SUBJECT: Final Plat and Site Improvement Plans for Reserve at River Oaks Phase IV
Open Space Conservation Subdivision

PC Case No: 2018-5461

Date: January 3, 2019
To: Kris McMaster, City Planner, Community Development
From: Bradley Kosco, P.E., P.S., City Engineer
Re: Reserve at River Oaks Phase 4 Plat and Traffic – Engineering Review

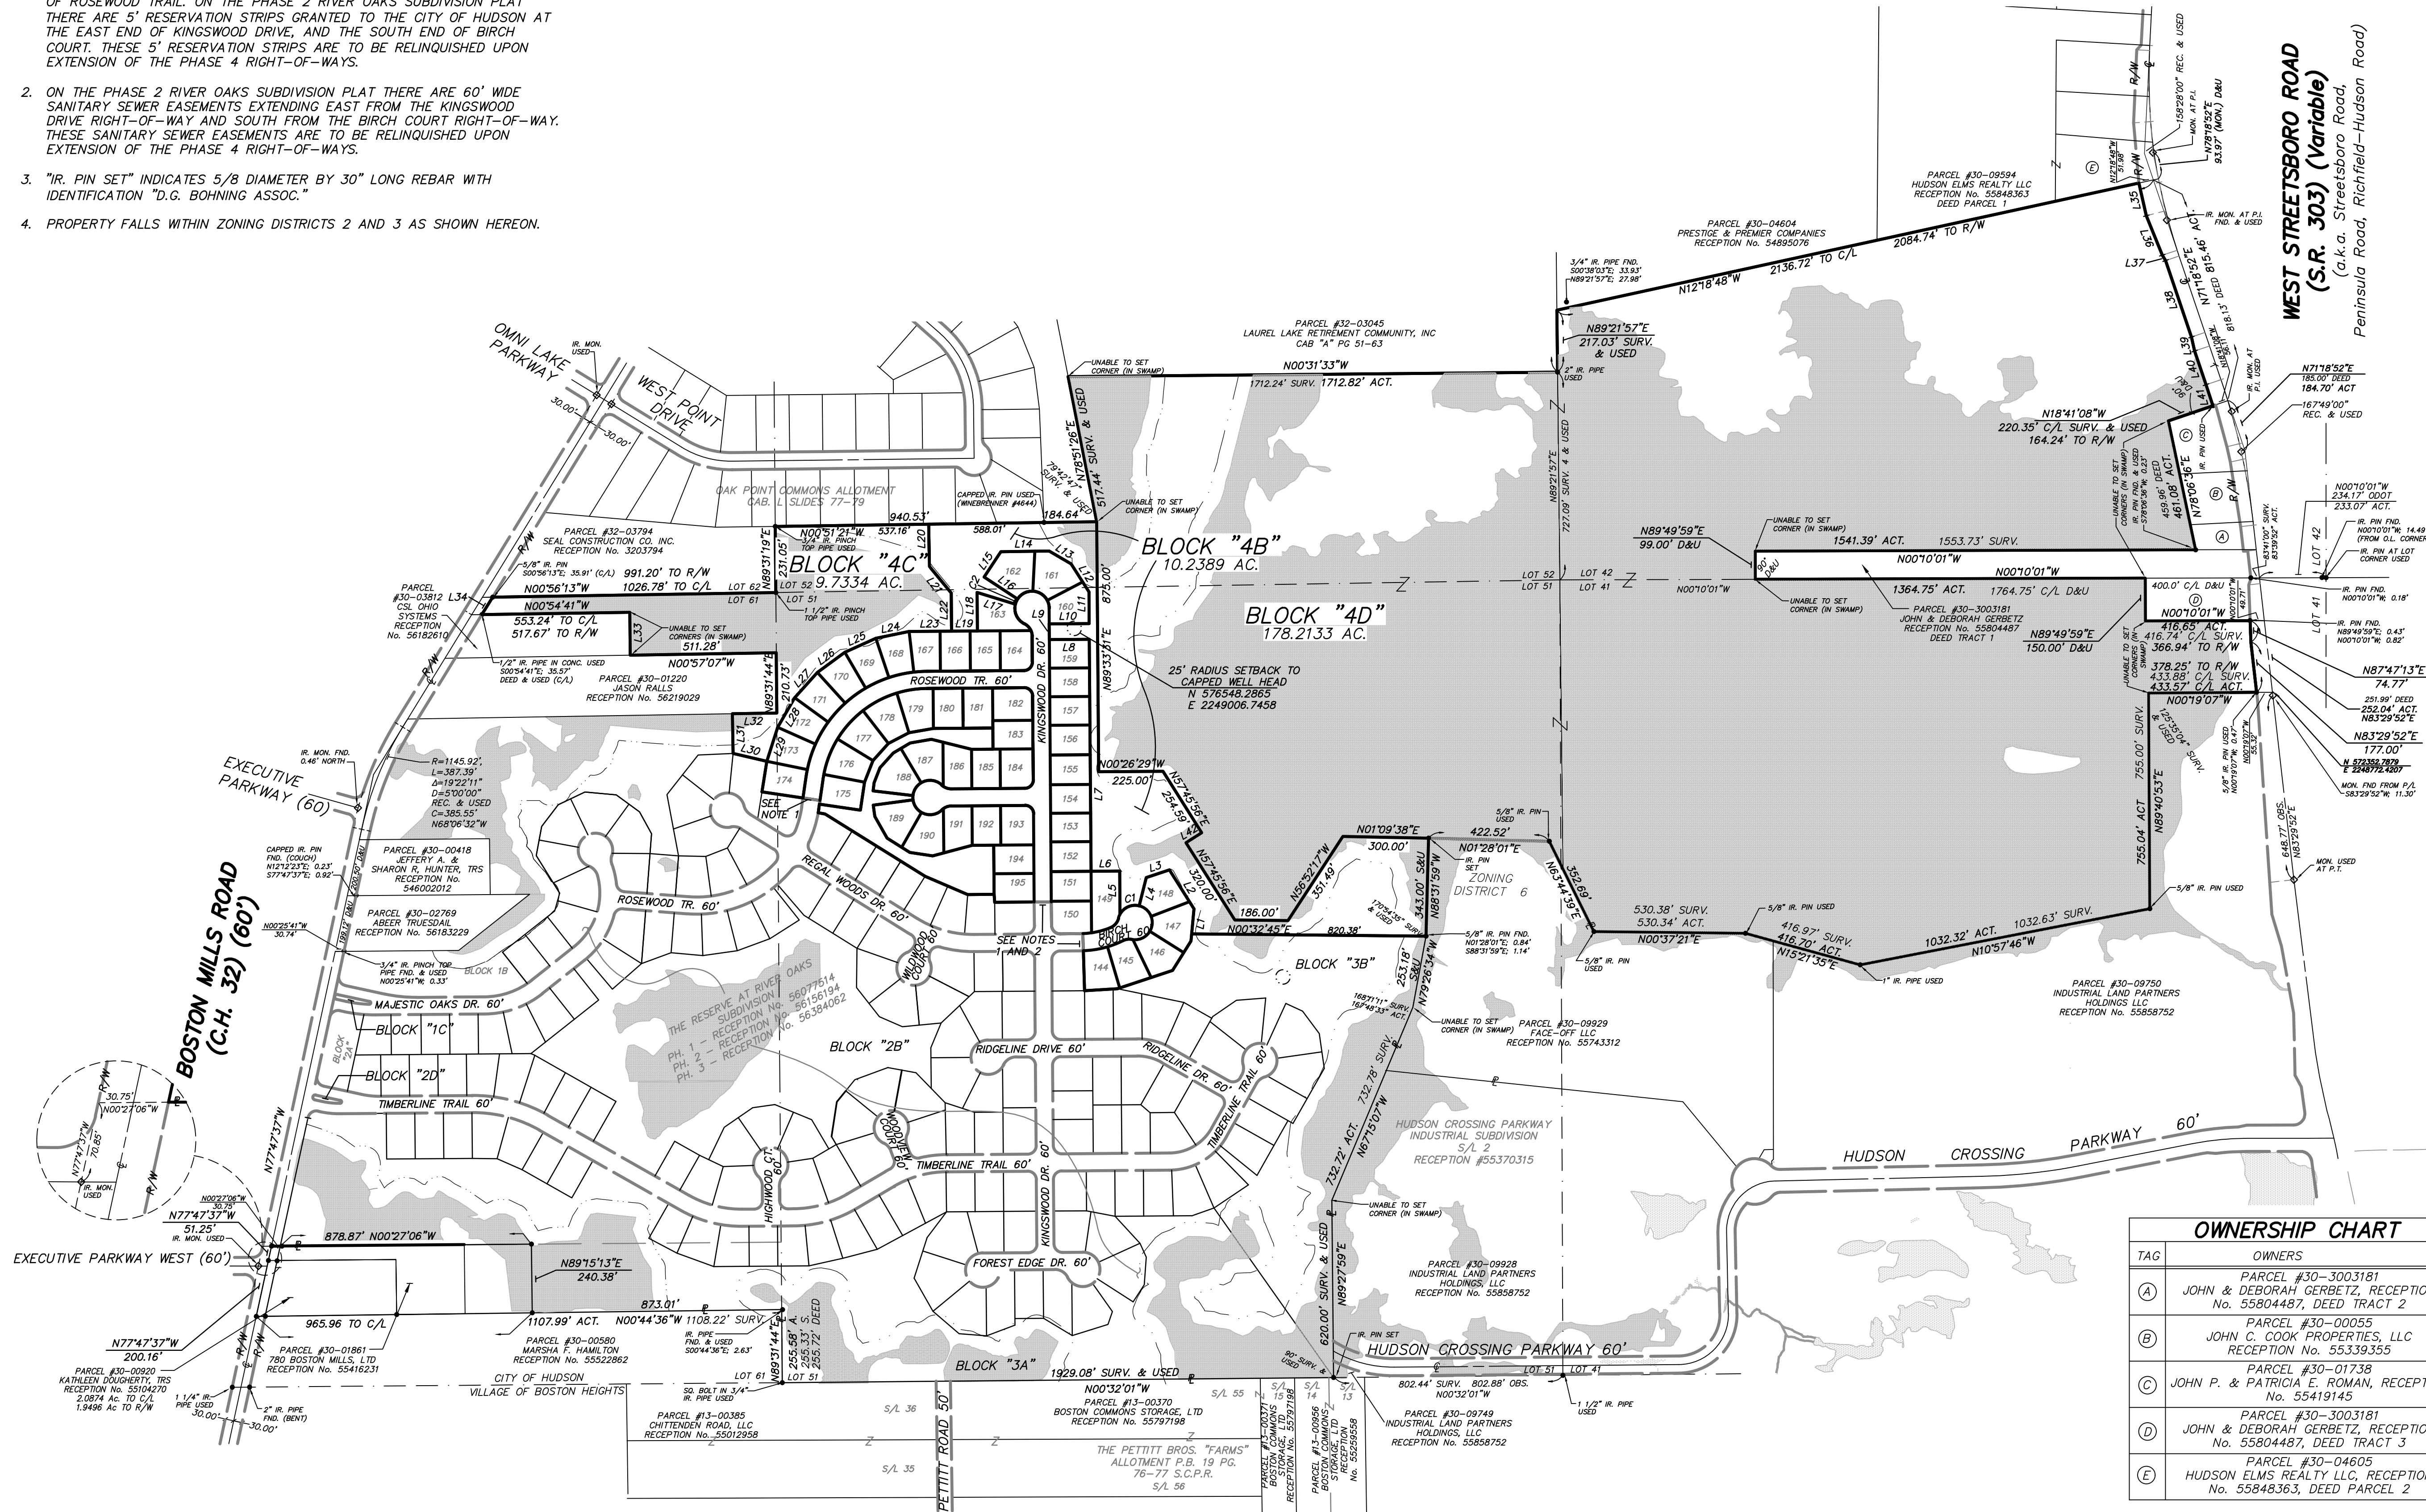
1. See red-line comments attached.
2. Provide closure sheets with next submittal.
3. Verify if Summit County Department of Sanitary Sewer Services will sign plat?
4. What is status of easement creation for proposed waterline extension from Hudson Crossing Parkway?
